MONTGOMERY COUNTY PLANNING DEPARTMENT
THE MARYLAND-NATIONAL CAPITAL PARK AND PLANNING COMMISSION

MEMORANDUM

REVIEW TYPE: Preliminary Plan of Subdivision

PROJECT NAME: Luhn Property

Figure 2: Preliminary Plan

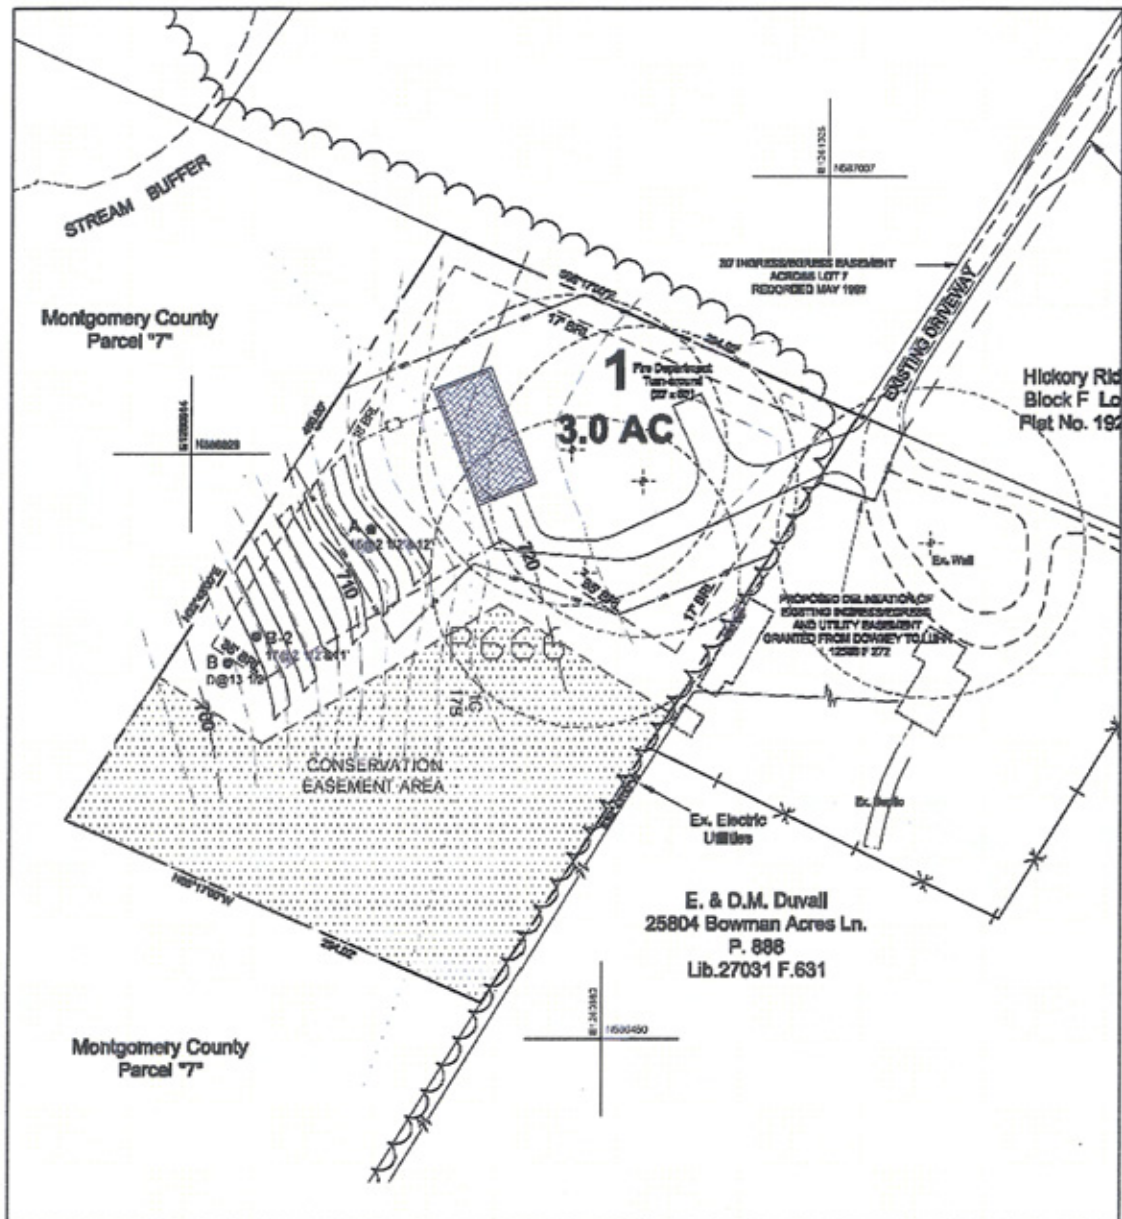
The lot which the applicant proposes to create will consist of 3 acres to accommodate a one-family detached dwelling unit. The current access point to the Property from the driveway within the 30-foot wide ingress/egress easement will be retained with a private driveway to the new dwelling unit extending from it. A fire department T-turnaround is required to be constructed by utilizing the new driveway on the Subject Property. An emergency vehicle pull-off area approximately 180 feet north of the site is also required to be constructed by the Applicant within the 30-foot easement. These two measures will provide appropriate maneuverability for emergency vehicles to and from the site.

A private, standard septic system and well will serve the new dwelling unit. A Category I Forest Conservation Easement is proposed to be located in the rear of the lot to protect forest that will not be impacted by this development.

The Subject Property is fully forested, containing 3.0 acres of forest. The applicant proposes to retain 1.20 acres and clear 1.80 acres of existing forest. This plan meets the break-even point, where no reforestation is required. The submitted forest conservation plan complies with the Montgomery County Forest Conservation Law. All retained forest will be protected in a Category I easement located on the Property.

Figure 3: Access Map

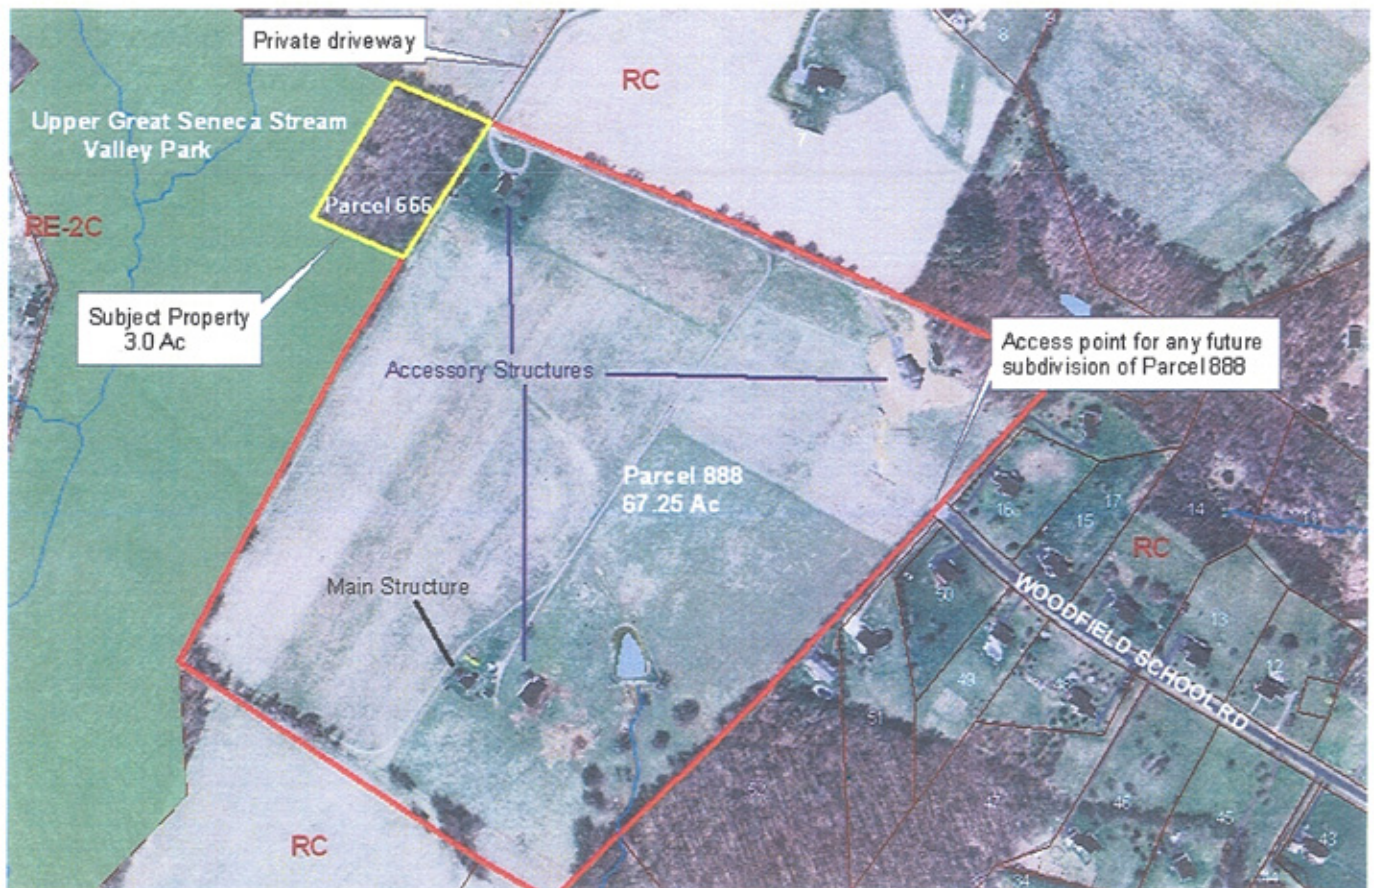
This lot requests the creation of a lot with no street frontage. The applicant, in his justification, argues that the Subject Property is land-locked and thus an exceptional circumstance exists in that the only access to the site is via a private lane in an easement through the adjacent property to the east. Furthermore, the applicant states that the driveway access to the site is free and clear of any obstructions and is suitable for the installation of underground utilities and for emergency vehicle access with the additional pull-off and turnaround improvements. Staff and Montgomery County Fire and Rescue concur that access is adequate to serve the lots for emergency vehicles and installation of the necessary utilities.

With the addition of the Subject Property, two lots will now be served by the private driveway. Parcel 888 directly east of the site contains only one main structure but many accessory structures, therefore, the 2 lot limitation will not be exceeded by this subdivision. Any future subdivision of Parcel 888 will be accommodated by extending Woodfield School Road, which is currently stubbed at the boundary of Parcel 888. This situation is depicted in Figure 3 below. Access to MNCPPC park property to the south and the open space area to the north will be unaffected by the new lot.
